GENSER-FORMAN INC.

TRIUMPH DISTRIBUTORS

TO: ALL DEALERS

HERALD CLUTCH ADJUST ÆNT

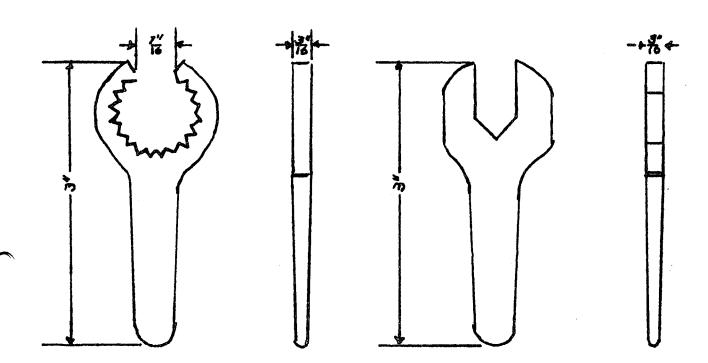
Firstly, a 7/16" single ended flare nut wrench should be cut and ground as shown also a 7/16" open ended wrench cut and ground as shown below.

The right hand is used to insert the flare nut wrench between the chassis member and the exhaust pipe and pass over the push rod on to the lock nut. The open ended wrench is used in the left hand to engage the adjusting nut, and this is done by inserting the wrench between the left hand foot well and chassis frame.

Correct adjustment is .080" clearance between the clutch slave cylinder push rod nuts and the abutment bracket. This adjustment is scheduled in the Maintenance Voucher Book for checking at pre-delivery, 500 mile free service and at each subsequent 3,000 mile service period.

SUBJECT: CABLE HARNESS

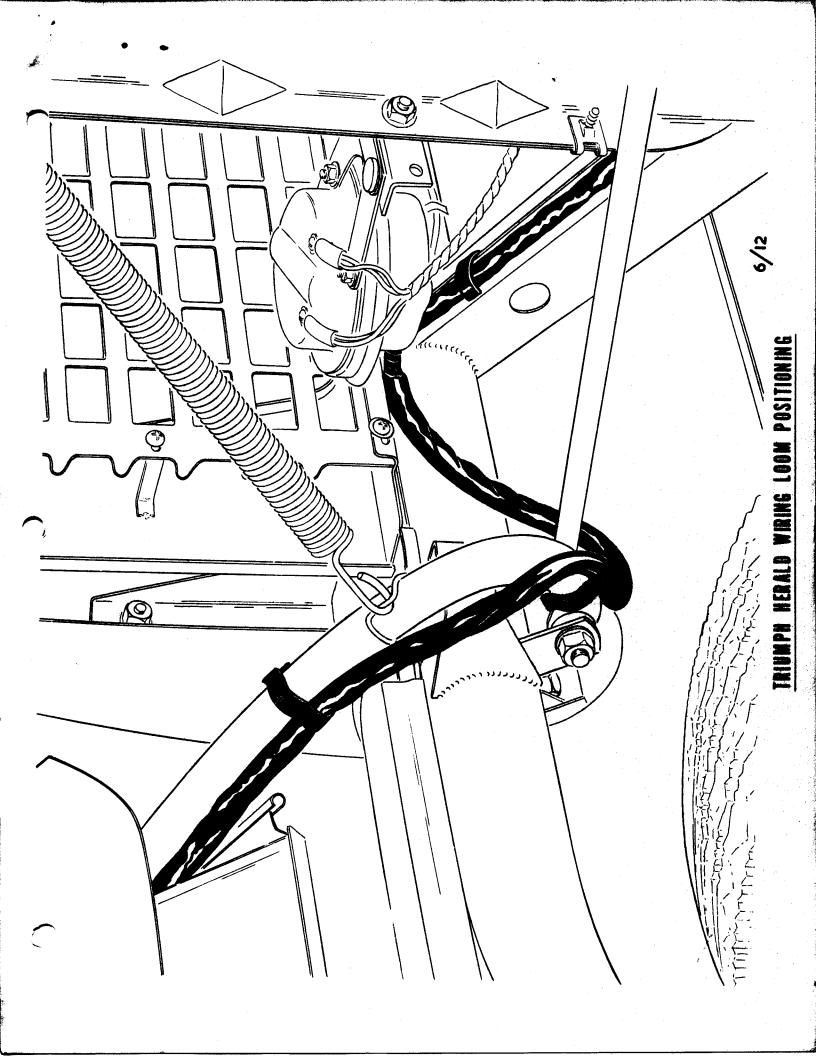
Positioning the cable harness on the inside of the tubular hinge member near the bonnet spring has caused, in a few instances, excessive chafing of the cable, resulting in some harnesses having been burned out.

If necessary, reposition the cable as shown on the attached illustration, that is, move the cable from the inside of the tubular hinge member to the cutside. This is readily carried out by removing the bonnet spring, moving the cable into the correct position and putting the spring back in position. This operation may be done in the matter of a few seconds and therefore, no reimbursement will be considered under our warranty terms.

OUTER AXLE SHAFTS

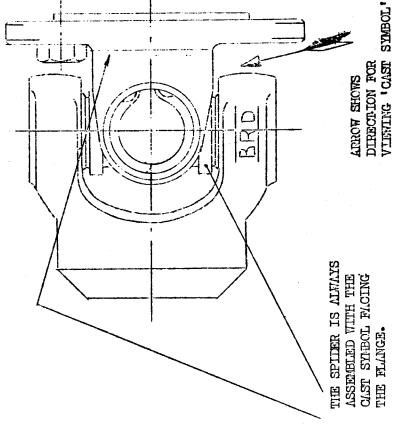
THE DIFFICULTY COMPONENT

i.e. THE SPIDER

ADD 5 CWT. OF BALLAST TO THE REAR END, ROLL THE VEHICLE FORWARD TO SPERAD THE WHEELS OUTWARD AT THE GROUND. WITH THE ALD OF A TORCH, THE CAST SYMBOL! ON THE SPIDER (i.e. THE SUSPECT COMPCNEWT) CAN BE SEEN.

Fig. 5. Removing spring eye bolt

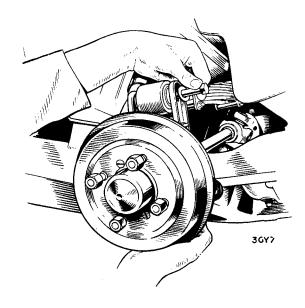
- 8. Remove the nyloc nut (11), and washer (10) from each damper attachment eye.
- Remove the bolt from the damper upper attachment eye and withdraw the damper and rubber bushes (9).
- 10. Lower and remove jack from beneath vertical link plates.
- 11. Whilst supporting brake assembly remove the nyloc nut, plain washer, and bolt from the road spring eye, Fig. 5.
- 12. Withdraw the hub and outer axle shaft assembly from vehicle.
